# CITY OF ALBUQUERQUE

RE: **Lot 1 Block 2 SAD 228  
8024 Canoncito Dr. NW  
Volcano Cliffs Subdivision  
Grading and Drainage Plan  
Engineers Stamp Date 11/6/19 (D10D003C1)**

**GRADING AND DRAINAGE PLAN**  
MALDONADO RESIDENCE  
8024 CANONCITO DR NW  
CITY OF ALBUQUERQUE, NEW MEXICO

## GRADING AND DRAINAGE - SITE PLAN

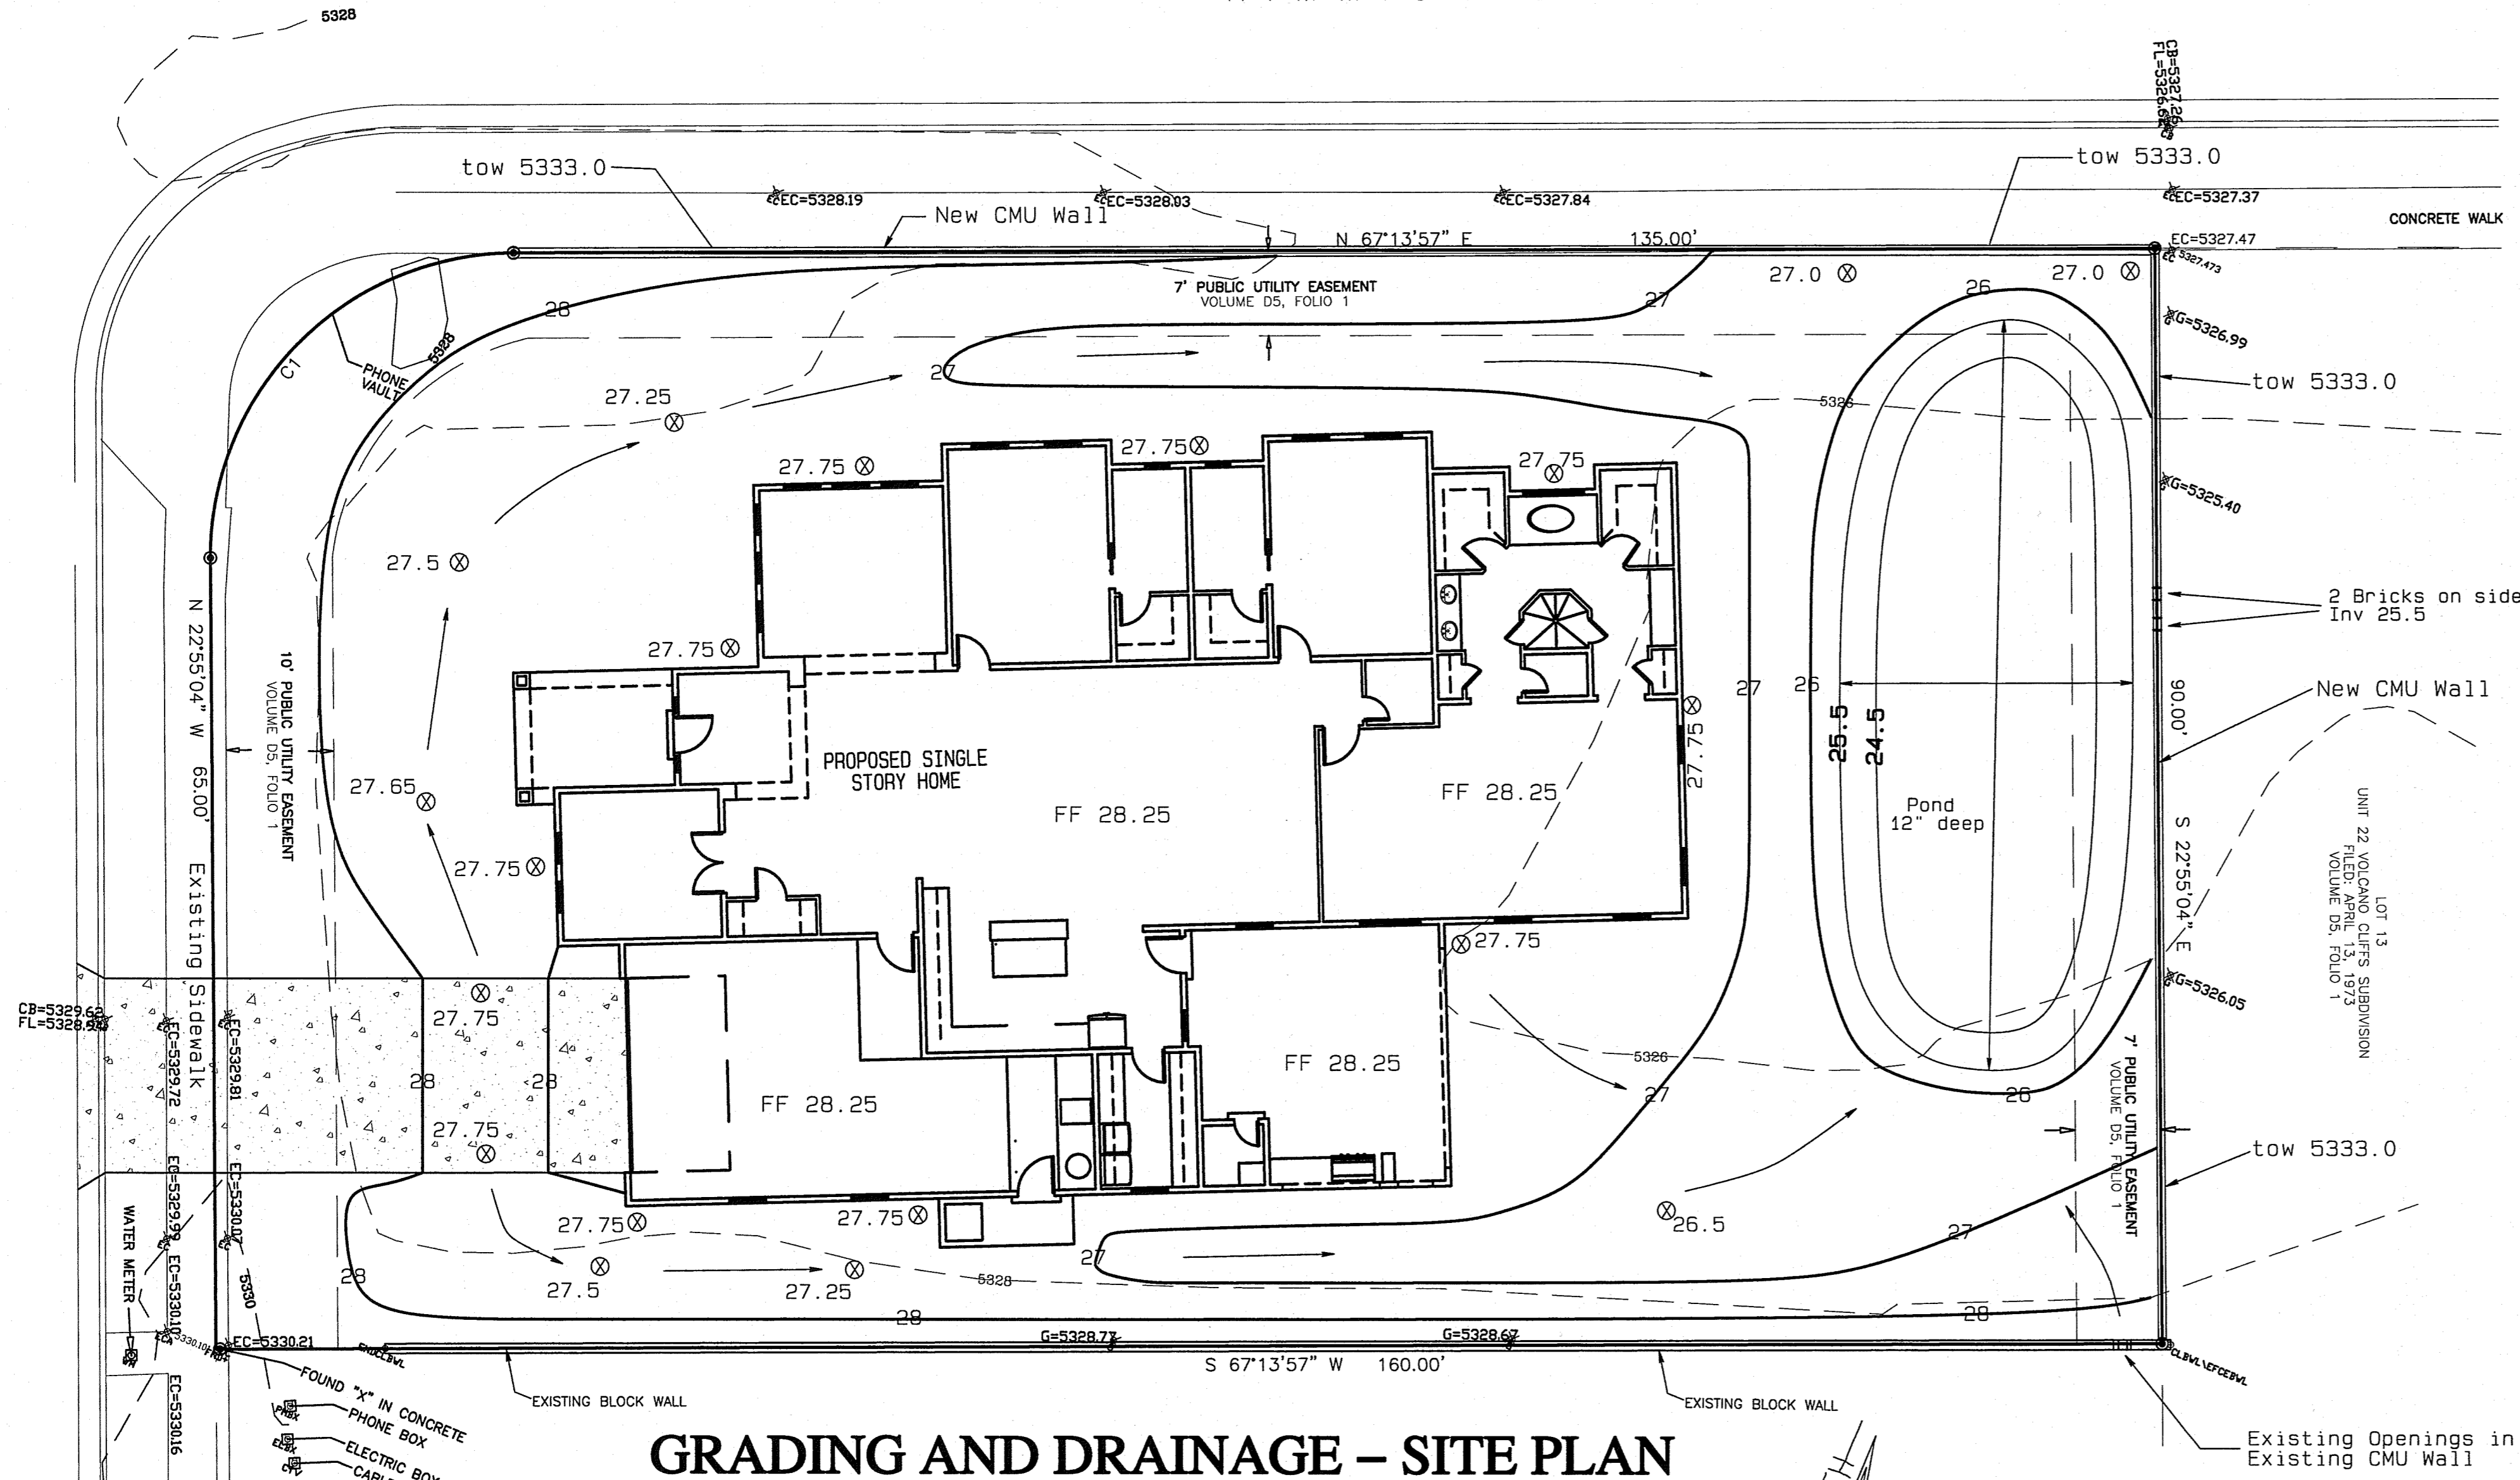
- Remove the openings in the rear yard. Provide openings in new garden wall so that flows can exit onto Kimmick Drive at the N.W. corner.
- No fees will be charged for the resubmittal.
